Office Action Summary	Application No. 10/698,382	Applicant(s) CHOI, CHANG-BONG	
	Examiner Timothy M. Ayres	Art Unit 3637

DETAILED ACTION

This is a first office action on the merits of application SN 10/698,382.

Lee '805 Figure 6

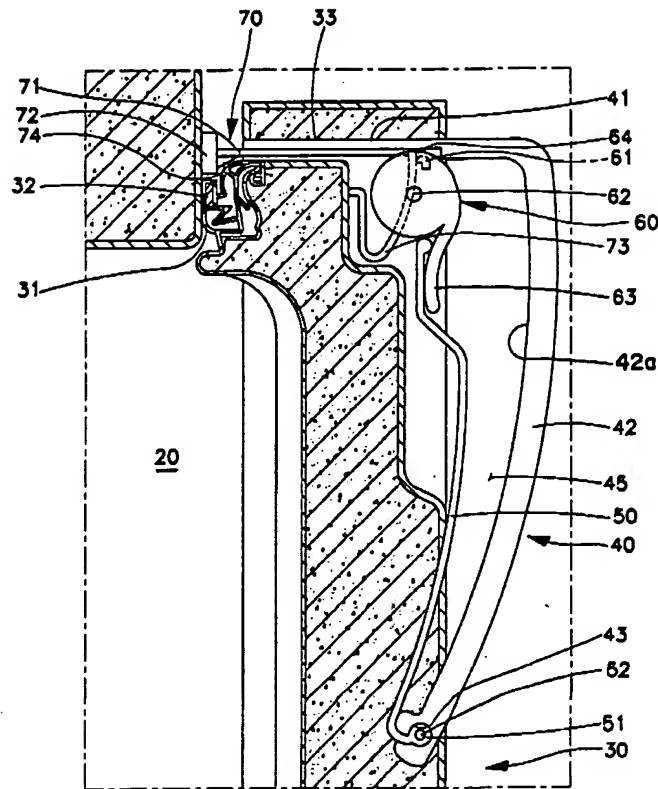
5,915,805 to Lee. The prior art (fig. 1, 2a, 2b, 2c) discloses a drawer body (3) that slides in and out on drawer rails (9). A door (2) is connected to pin (7), which is the axis of rotation. The door (2) has a gasket (8) around the edge that comes in contact with the main refrigerator body (1) when the door is closed. The gasket (8) is formed below the axis of rotation (7). The drawn prior art does not disclose expressly a cushion member or a plurality of cushion members that prevents contact of the gasket with the main body of the refrigerator when the door pivots on the axis of rotation and that is installed on the door of the refrigerator. Lee '805 discloses a refrigerator door (30) with a handle (40). A cushioning member (72) is towards the outside edge of the door side of the gasket (31), in figure 6 this side is above. The cushioning member (72) is attached to the handle (40) such that when the door pivots, the gasket (31) is prevented from contact with the main body of the refrigerator (10).

For 1, 3, and 4, at the time of the invention it would have been obvious for a person of ordinary skill in the art to take the drawn prior art in this application and add the cushion member (72) of Lee '505 to the door of the refrigerator or to install it on main body of the refrigerator below the gasket, since below is side of the outside edge of the door, in order to prevent compression of the gasket between the door and the main body of the refrigerator and to make the door easier to open.
